Consideration of matters raised during consultation on earthquake processing and disposal activities at the Burwood Resource Recovery Park and Burwood Landfill

Figure 1
Site locations and L1 zone boundary

Figure 2

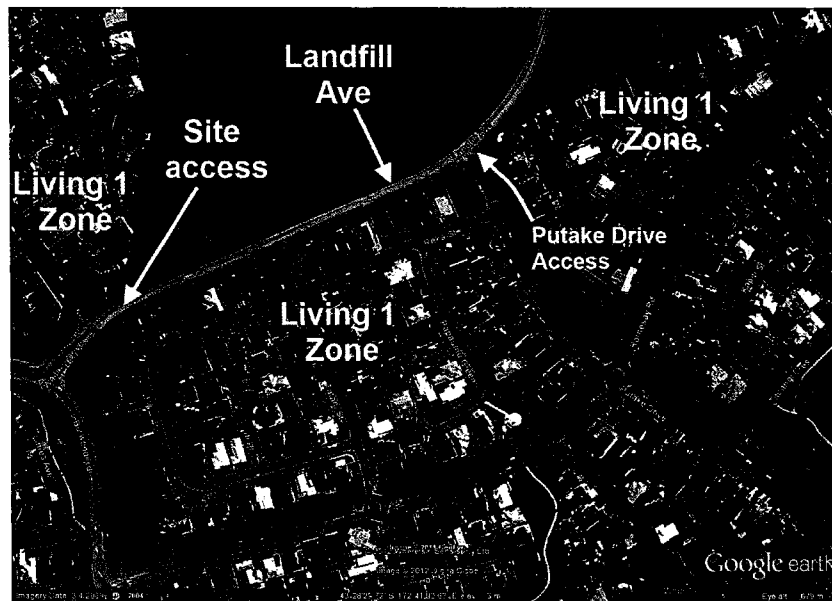
- 5.2. Notwithstanding that truck movements have decreased significantly, residents have continued to object to nuisance effects from noise, dust, litter and warning lights on the trucks particularly at night-time. As a mitigation measure, Putake Drive has been used as an access in rotation with the main access, to relieve effects on residents near the main access and those adjacent to Landfill Avenue. However, this has simply transferred effects to a more sensitive area, and the applicants have now agreed to close this access and concentrate on mitigation of effects at the main access.

- 5.3. The close relationship of the Living 1 zone residential area to the site accesses and the waste transport route on Landfill Avenue are shown in Figure 2 below.

- 5.10. My main reason of concern that a lower fence would not provide sufficient noise attenuation is that the number of trucks used by Mr Smith to model the contours is not representative of the busiest night-time hour. Referring to section 4.4 of the report, the figure of 20 tanker movements per hour during night-time is associated only with Site P; however haulage trucks from the BRRP will also use the site access and road between 6 am and 7 am, which is a noise-sensitive time of the day. I also note that the number of trucks during daytime (320) is inconsistent with the number of truck movements in the AEEs (refer paragraph 5.1 above) which indicate there would be 940 truck movements involving 470 trucks (i.e. 740 movements for Site F, and 200 for the BRRP during daytime).
